# Initial Project Review

## Preliminary Plat: The Viewpoint

**Application Number: 897433****Tax Parcel Numbers: 042030-1027 and -4002**

# Proposed Preliminary Plat Map for The Viewpoint, revised February 14, 2019

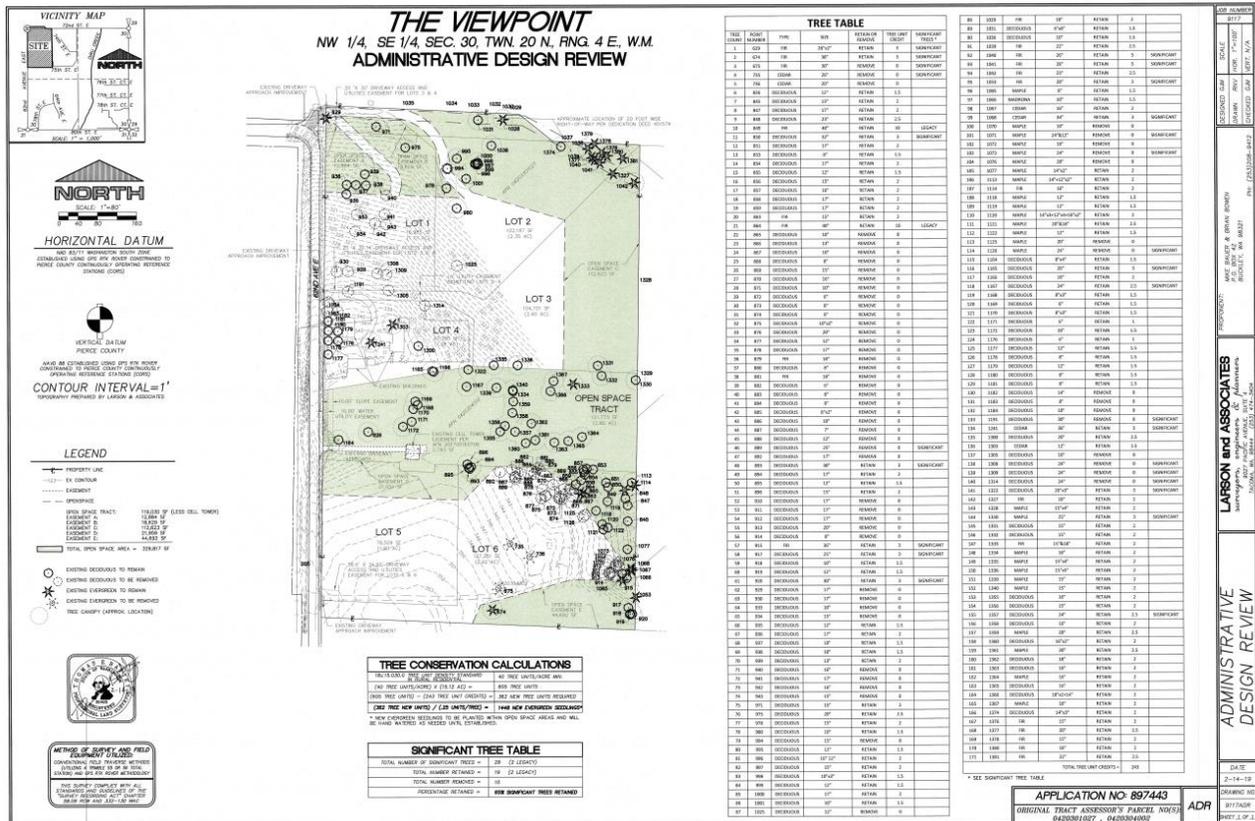
- Development Engineering has requested the following revisions:
  - Need to verify entering site distance (ESD) and safe stopping distance (SSD) are met at both access locations.
  - The gate key pad needs to be placed so the vehicle does not need to cross the opposing lane of travel.
  - Need to provide a proposed roadway cross section.
  - Need to show the required 10-foot of right of way dedication along the frontage.
  - Need to address plat mark-ups and survey comments.

- It appears there may be a Group B well on the southerly parcel boundary. Please locate it and show the public well radius on a revised site plan for further consideration.

Regarding the revised plat layout, Resource Management has no additional comments. Current Planning staff has requested information on the species of the “deciduous” trees proposed to be removed to determine if they are trees listed on the significant tree table. Development Engineering has stated that a license from the County Engineer will be required to use unopened 62<sup>nd</sup> Avenue East right-of-way as a driveway access for Lots 1 and 2. The earlier comment regarding the gate key pad location is no longer relevant since there is no road proposed. The Fire Prevention Bureau has stated that a water system permit has been submitted for review. As of the date of this report, no other comments on the revised layout have been submitted
